## SUNBELT RENTAL BUILDING ADDITION JSP14-68

Consideration at the request of Ideal Contracting for the approval of the Preliminary Site Plan. The subject property is located in Section 17, south of Grand River Avenue, east of Wixom Road and west of Beck Road in the I-2, General Industrial District. The applicant is proposing to expand the existing 10,353 SF construction equipment rental space by adding 6,250 SF three (3) bay pre-manufactured metal building addition for equipment repair and related parking and landscape improvement. The applicant is not proposing any storm water improvements on site.

# PLAN REVIEW CENTER REPORT

**SUBJECT: Sunbelt Rental Addition, JSP14-0068, Traffic Review of 2<sup>nd</sup> Revised Preliminary Site Plan, PSP15-0011**

*C2 plan for  
NO PARKING FIRE LANE  
signs / 1-28-15*

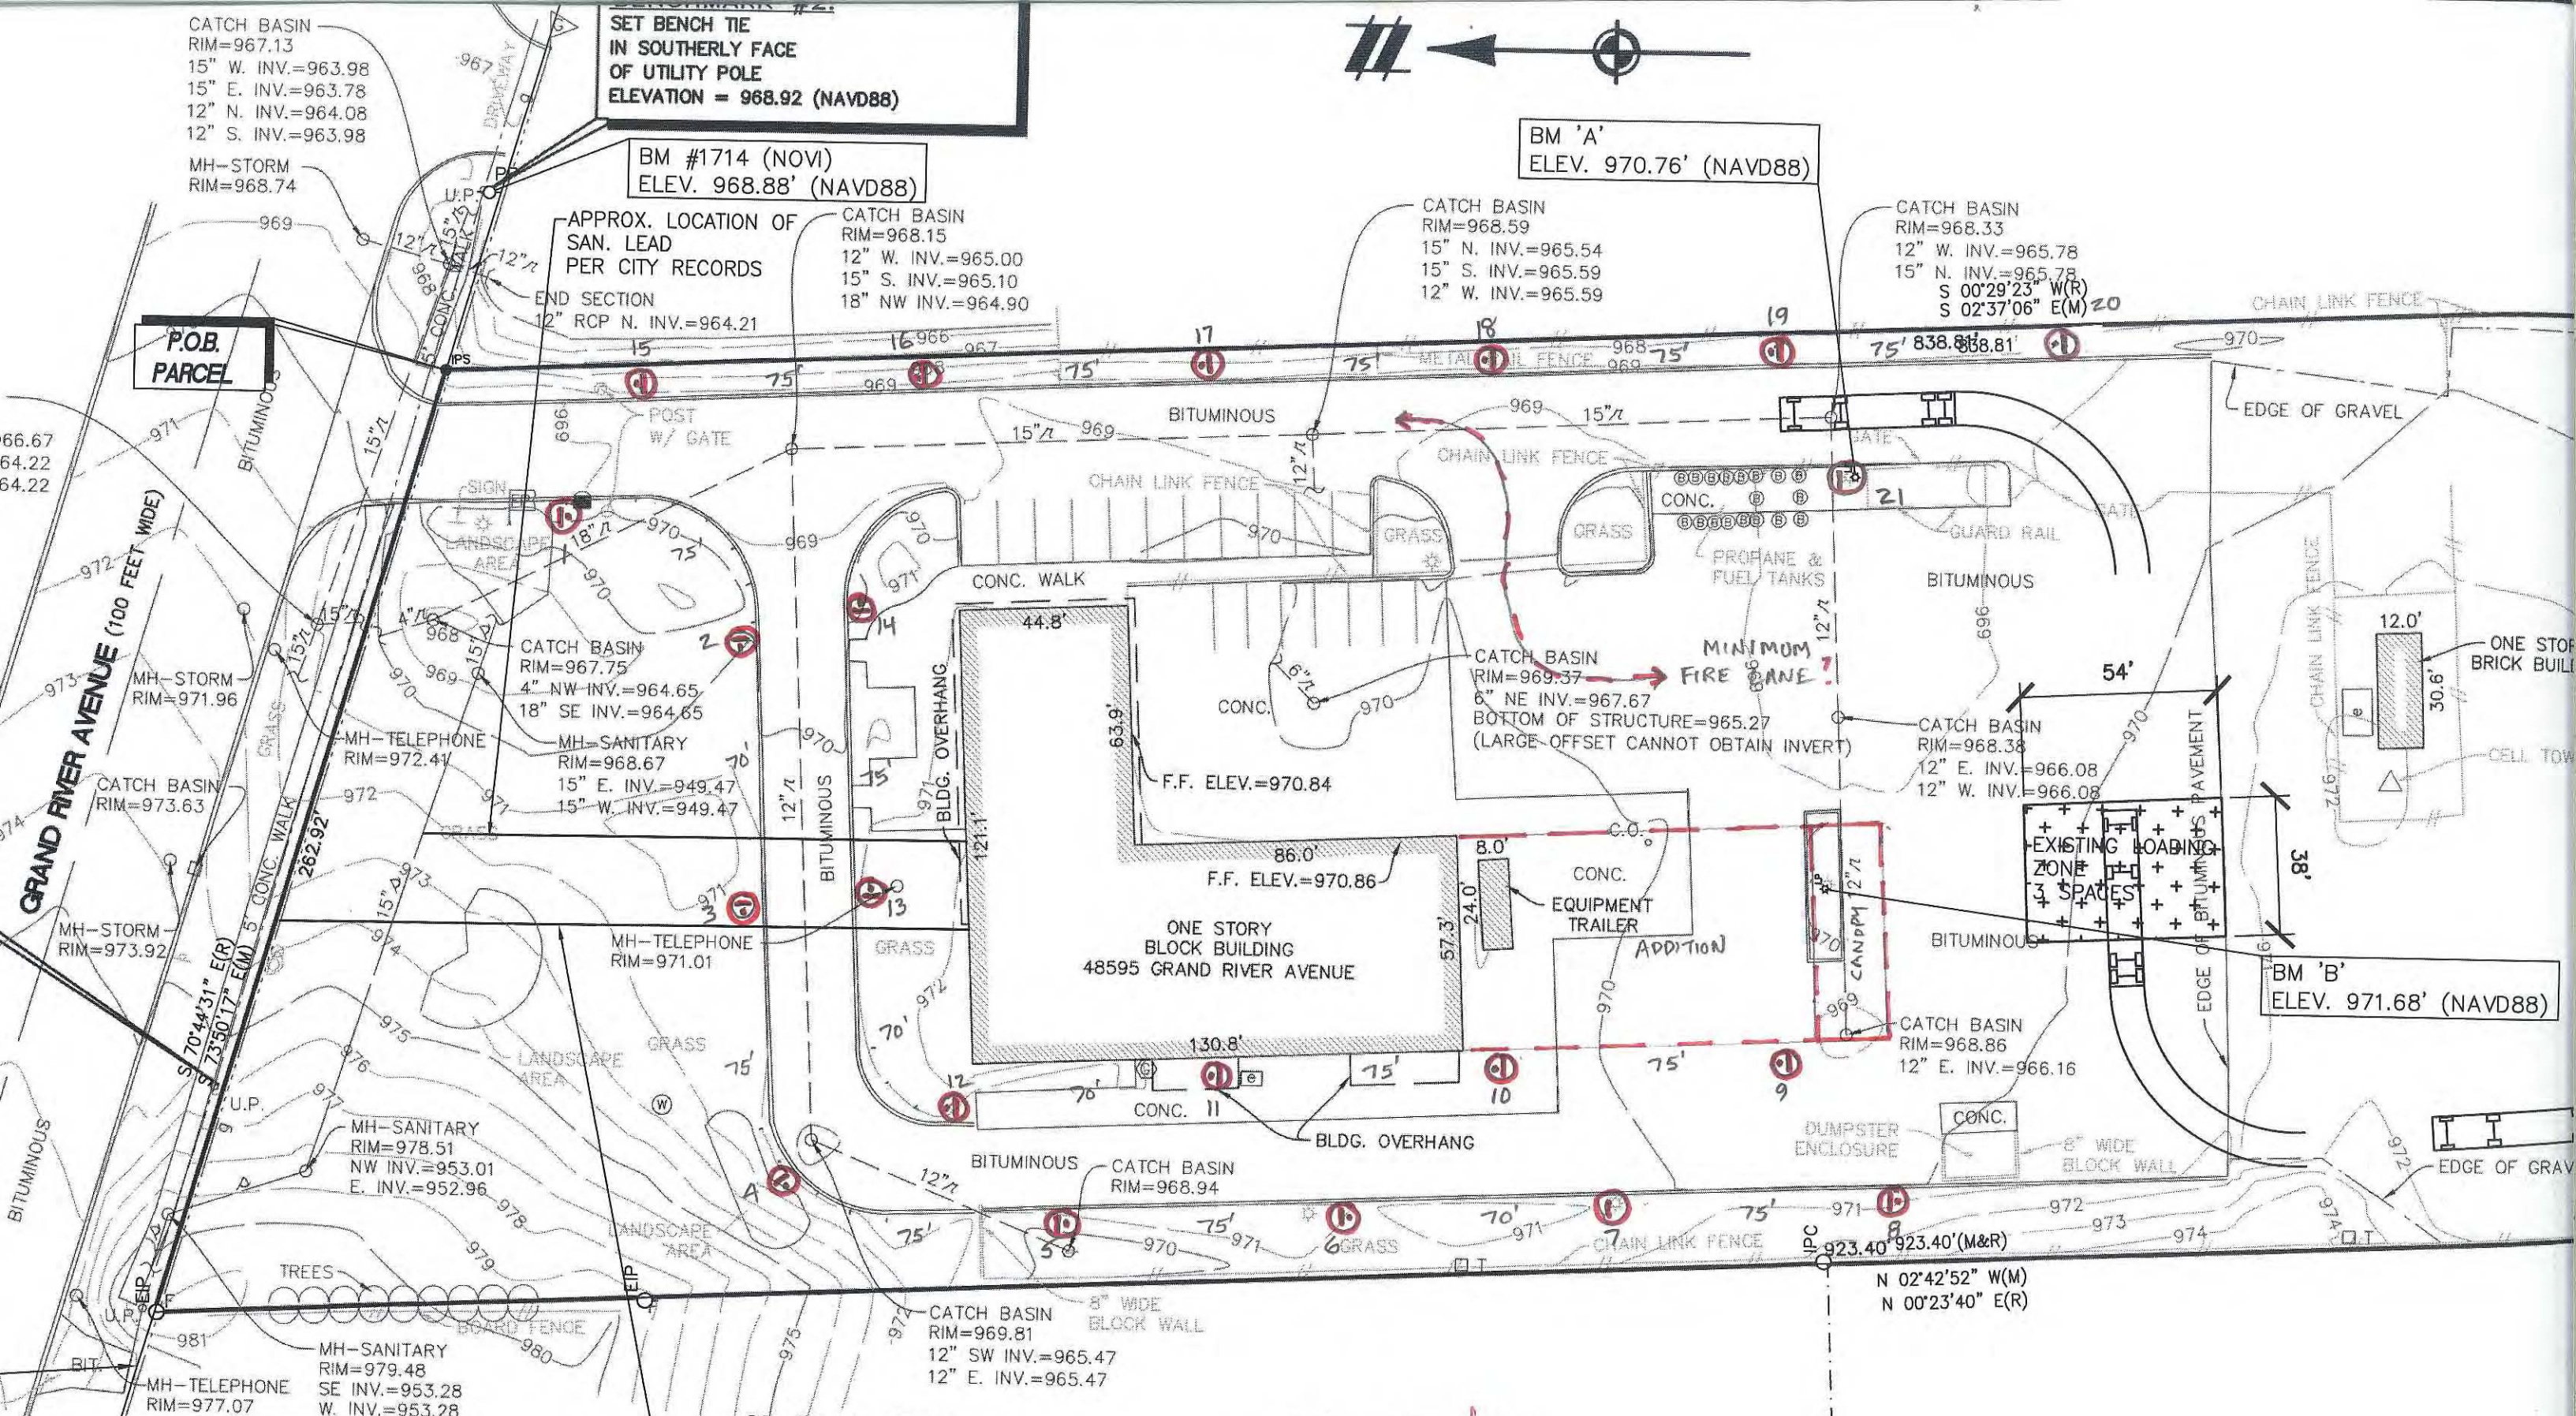
8. Based on the previous out-of-scale plan, we had estimated that a total of 20 NO PARKING FIRE LANE signs would be needed to meet the requirements of Sec 15-17 of the City's Fire Prevention and Protection Ordinance. Our earlier review quoted the relevant ordinance language, which indicated that such signs are to be "erected no further than seventy-five (75) feet apart in all areas designated as fire lanes... **All fire lane signs shall be placed at a right angle (ninety (90) degrees) to the designated fire lane so that they may be readily observed by vehicular traffic.**" **The plan now under review shows such signs parallel rather than perpendicular to the curb, and the plan must therefore be revised accordingly.**

9. Our previous letter also indicated the need for NO PARKING FIRE LANE signs along the entire west façade of the expanded building, whereas the plan under review does not show any signs along the building south of its northwest corner – which are needed in order to serve northbound traffic along this fire lane. Also, the proposed sign spacings are highly irregular – scaling between 58 ft and 77 ft, with many in the mid-60s range – and generally closer than necessary. Since we now have a properly scaled site plan to review, we took the initiative to develop our own signing plan on the relatively clean "Existing Conditions" sheet (C-1 of 7). **To provide the needed coverage and improve the spacing of signs, our signing plan (attached) should be adapted to the final site plan, and the Signing Quantities table on sheet C-3 adjusted accordingly.** If the Fire Marshal agrees with our previous assumption that the designated fire lane can pass between the two raised end islands east of the building, a total of only 18 signs would be needed (two fewer than previously estimated). If the fire lane must pass to a point south of the new parking bay, a total of 21 signs would be required.

7. No comment.
8. The plans will be revised to represent signs that will be perpendicular to the curb.
9. The provided signing plan, that includes 20 signs, will be incorporated in the revised plans.
